Access Compliance Report

Public Rights-of-Way

(Curb Ramps)

Intersection ID: 19064	Main Street: GROSNER_PL	Cross Street: RAMA_RD	Location:	W
ADA ID: 10E2CB040B9D	Ramp Type: PerpDiag	Initial Pass/Fail: Fail	Overall Compliance: No	Severity Score: 25
Codes/Mitigation Info/Possible Solution		Field Measurements/Component Compliance

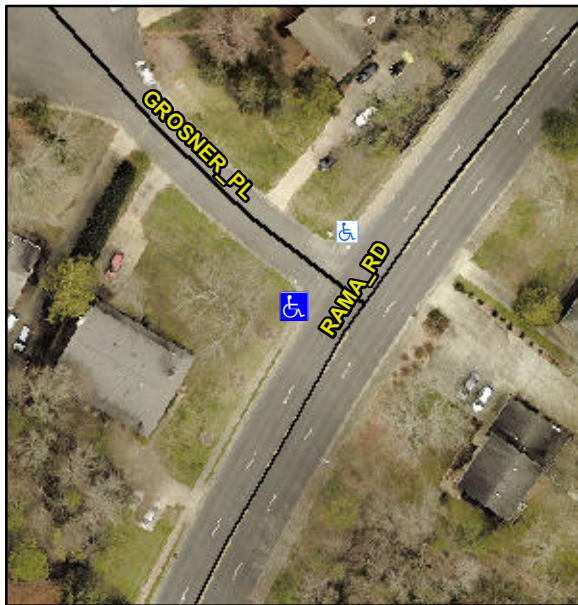
Not Found, R304.2.2, R304.5.3

Compliance	Description	Data	Compliance	Description	Data
N/A	Ramp Length (in)	70.0	No	Ramp Slope (%)	10.3
Yes	Ramp Width (in)	48.0	No	Ramp XSlope (%)	6.6
N/A	Flare Type LT	N/A	N/A	Flare Type RT	N/A
N/A	Flare Slope LT (%)	N/A	N/A	Flare Slope RT (%)	N/A
N/A	Flare Traversable LT?	N/A	N/A	Flare Traversable RT?	N/A
N/A	Landing Length (in)	N/A	N/A	DWS Provided?	N/A
N/A	Landing Width (in)	N/A	N/A	DWS Contrast?	N/A
N/A	Landing Slope (%)	N/A	N/A	DWS Length (in)	N/A
N/A	Landing X Slope (%)	N/A	N/A	DWS Full Width?	N/A
N/A	Landing Curb? (Y/N)	N/A	N/A	DWS Offset (in)	N/A
N/A	Shared Landing?	N/A			
N/A	Gutter Ponding?	N/A	N/A	Gutter Slope (%)	N/A
N/A	Gutter Lip Ht (in)	N/A	N/A	Gutter X Slope (%)	N/A
N/A	Painted X Walk1?	No	N/A	Painted X Walk2?	No
	X Walk 1 Direction	To SE		X Walk 2 Direction	To NE
N/A	X Walk 1 Width (in)	N/A	N/A	X Walk 2 Width (in)	N/A
	X Walk 1 Slope (%)	6.3		X Walk 2 Slope (%)	4.2
	X Walk 1 X Slope (%)	0.2		X Walk 2 X Slope (%)	4.2

Remove & Replace Curb Ramp With Two New Directional Ramps or Equivalent.
